Overview: Production error in version 1.0 harnesses; The immobilizer wire (orange/black) is in pin position #4 instead of pin position #5. Although an effort to correct the issue was made, some quantity of harnesses did get shipped before the issue was spotted. We are advising to inspect the harness BLADE connector before attempting to install harness or program the module. This issue is not known to affect the version 2 harnesses, which require no modification.

Overview: Early versions of the FTI-STP1 harness require modification for **automatic transmission (AT)** applications, some of the product was able to be modified before release, but a small quantity was released without modification.

FTI-STP1: Installation and Configuration Notes

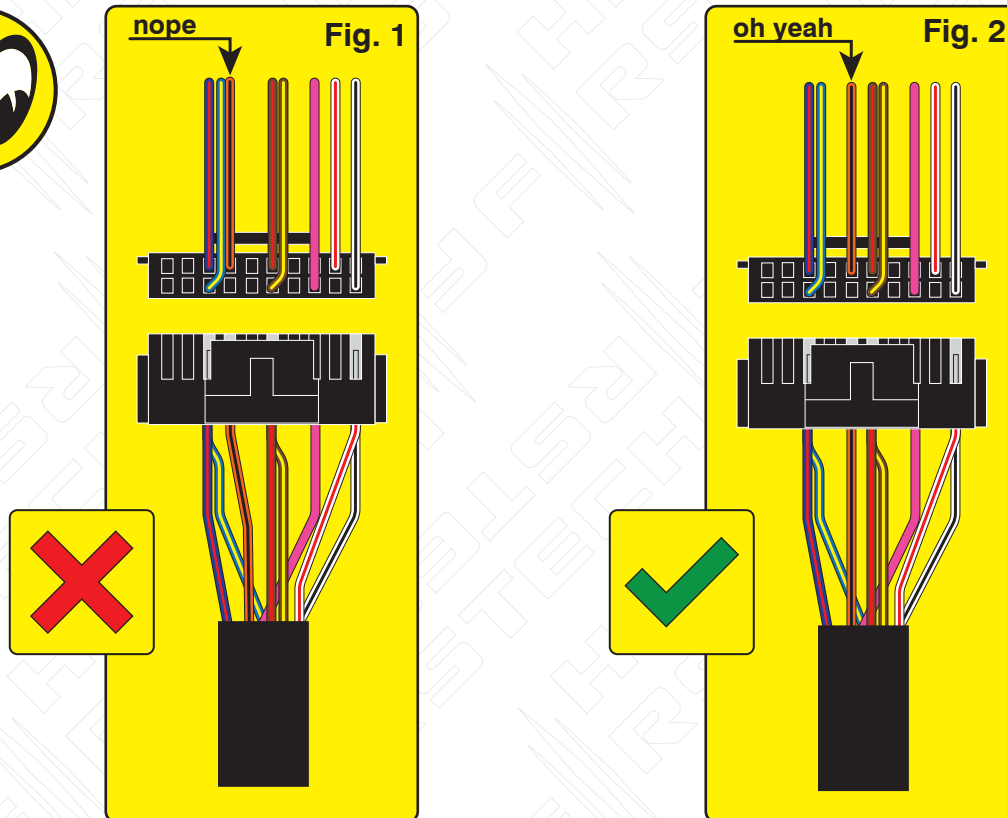
Issue: Module fails to program correctly to vehicle, does not allow the vehicle to be remote started.

Correction: Step 1.) Locate the orange/black wire and confirm whether it is positioned as illustrated in Fig. 1 or Fig. 2. If the wire is as illustrated in Fig.1, proceed with Step 2 through 5 and complete the repair procedure outlined, if the wire is as illustrated in Fig. 2, correction is not necessary, proceed with harness installation and module programming.

Step 2.) Using a pick, lightly depress the catch that secures the terminal in the housing then remove the wire and terminal from the housing.

Step 3.) Using a fine tip razor or utility knife, insert the blade beneath the terminal catch and raise it slightly, so that it can be reused to secure the terminal when reinserted into the BLADE connector housing.

Step 4.) Refer to Fig. 2 for correct position of the orange/black wire (next to brown/red) then reinsert the terminal, pressing lightly until the catch 'snaps' into place, securing the terminal in the connector housing.

Step 5.) The repair is complete, proceed with installation and programming.

MODIFICATION REQUIRED FOR A/T APPLICATIONS, ONLY WITH v 1.0 HARNESS

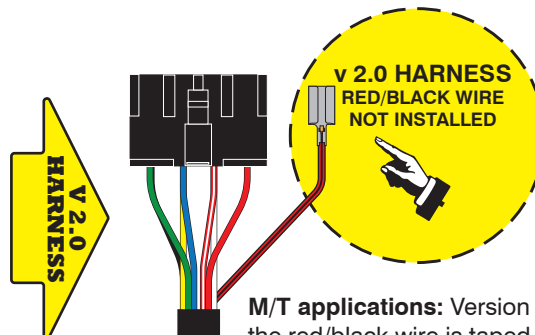
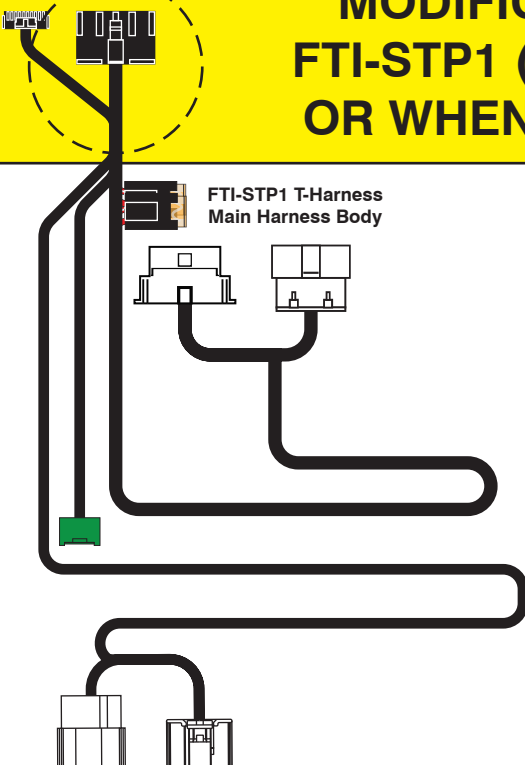
Issue: The FTI-STP1 T-harness has been designed to be compatible with A/T (automatic transmission) & M/T (manual transmission) applications, but due to an oversight in early production runs, the selection was defaulted to M/T mode.

Using a harness configured for an M/T application, in an A/T equipped vehicle, could result in vehicle module damage, it is advised that the harness be returned to A/T mode before installation in vehicles equipped with an automatic transmission.

Correction: Locate the **red/black (+ Clutch)** wire provided in the CN1 connector of the main harness assembly. Cut the **red/black** wire, either flush to the CN1 connector, or leaving enough wire exposed so that you can insulate and secure the ends of the wire that remain after cutting. Insulate each of the remaining ends of the **red/black** wire and secure to prevent any possibility of a short circuit. **If the red/black wire has already been disconnected, no further modification is required for A/T applications**

M/T applications: Version 2.0 harness, the red/black wire is taped to the main harness when shipped, and must be installed in the CN1 connector when installed.

A/T applications: Leave the red/black wire taped to the harness, it is not required for A/T applications
